CUMNOR PARISH COUNCIL

BOTLEY WEST SOLAR FARM (BWSF) REF: EN010147

WRITTEN REPRESENTATION OF CUMNOR PARISH COUNCIL

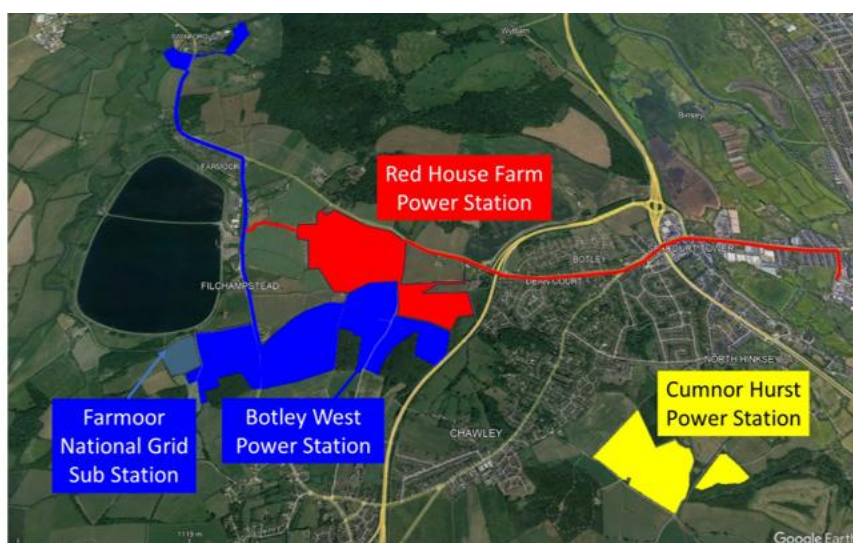
10. As CPC raised in its [oral submission to the 13th May PINS Preliminary hearing](#), given the applicant's inadequate submissions, it remains concerned about how cumulative impacts of the Botley West power station, the Red House Farm power station (an immediately adjacent site with a current planning application to Vale of White Horse District Council under the Town and Country Planning Act) and the National Grid substation proposals will be assessed.

CPC notes that, to the best of its knowledge it is still the only entity to have mapped these cumulative impacts (see CPC Relevant Representation), and map below.
